ENGINEERING TECHNICAL BULLETIN No. 107

Field Handbook No. 90-2807-1

**Improving the Noise Level
of the
SP-600 Receiver
using a
Nuvistaplug**

March 1965

FIGURE:2 NUVISTAPLUG IN SP-600

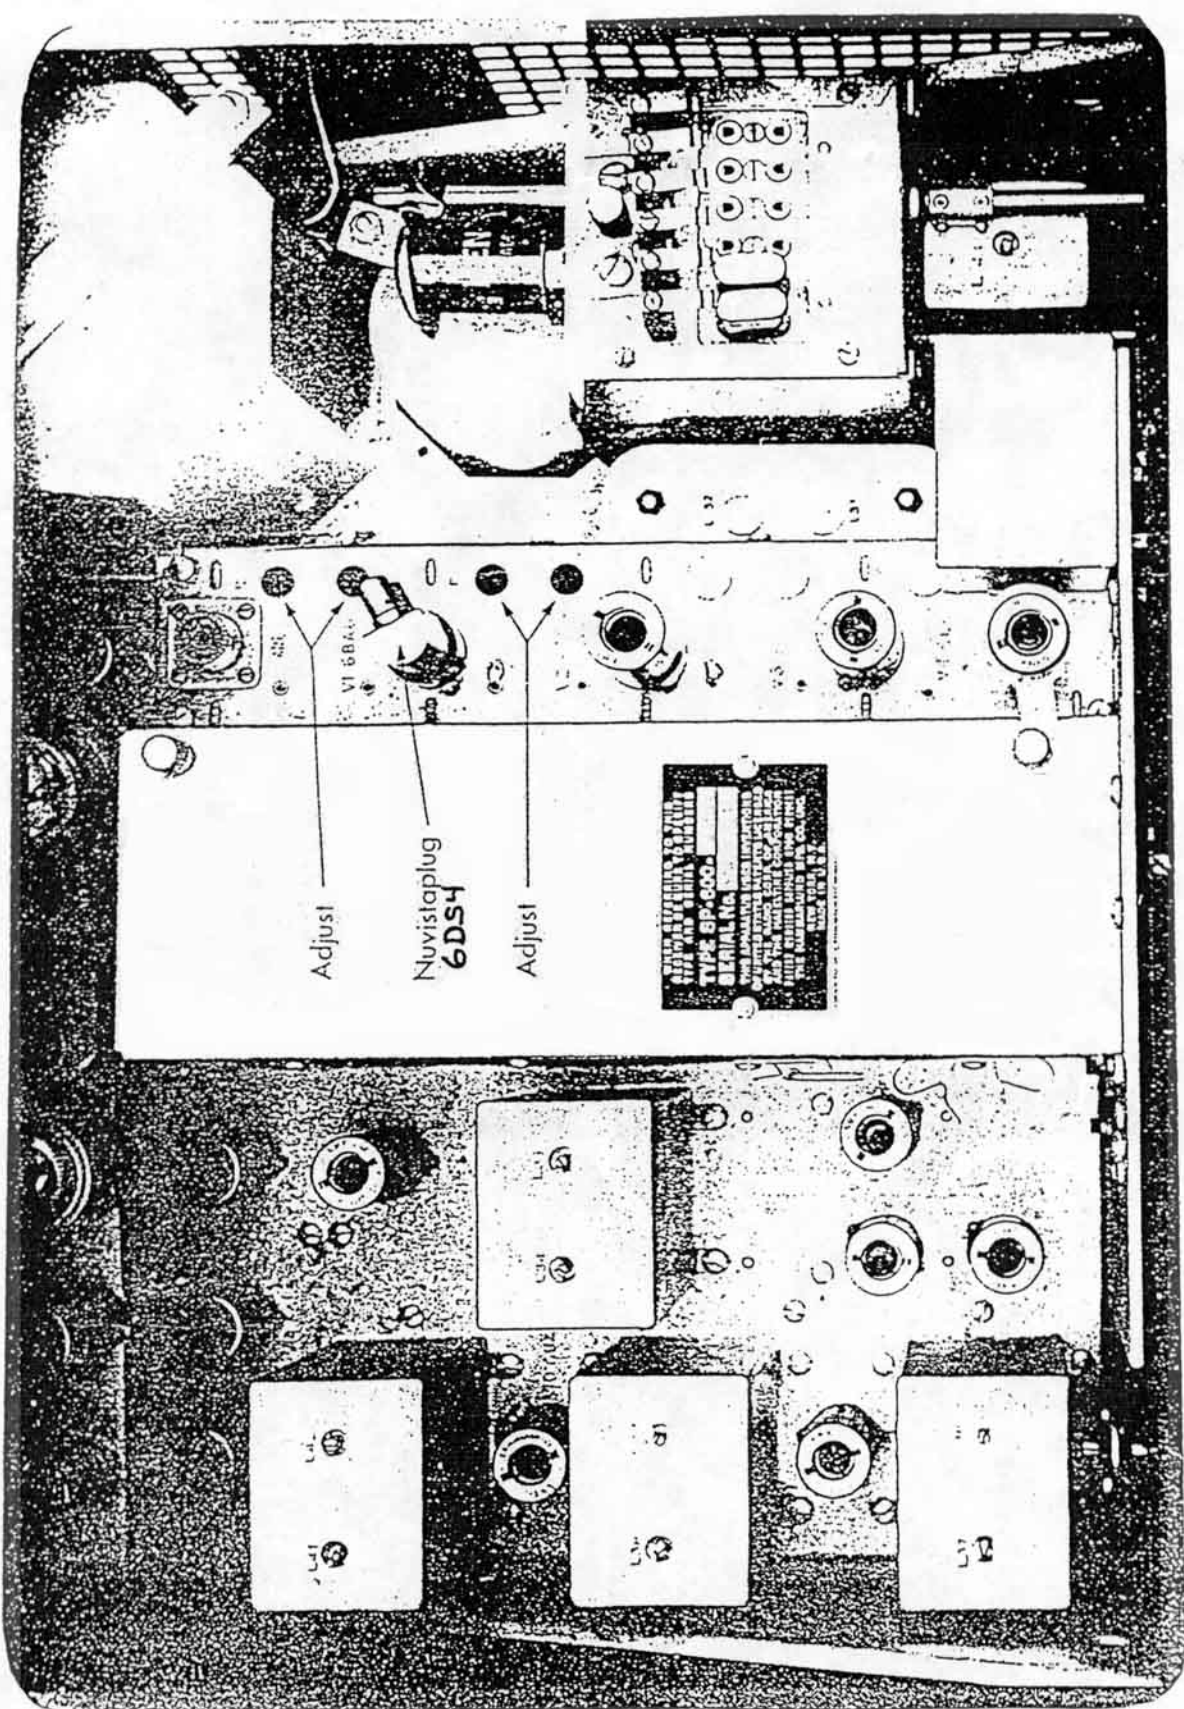
3. Replace the V1 tube 6BA6 in the first RF amplifier stage with the Nuvistaplug Model 675.(**6DS4**)
4. Set the MOD-CW switch to CW and the AVC-MANUAL switch to MANUAL; set the RF gain for best sensitivity. Tune the receiver until the CW source is heard.

6. Adjust the trimmers for the antenna and the first RF stage while listening to the tone output (See Figure 2). Each time an improvement is made, decrease the amplitude of the CW generator output so that the audio tone is barely heard under the internally generated white noise of the receiver. In most cases the two trimmer capacitors marked "C" need to be readjusted, but the two trimmer inductors marked "L" do not need readjustment.
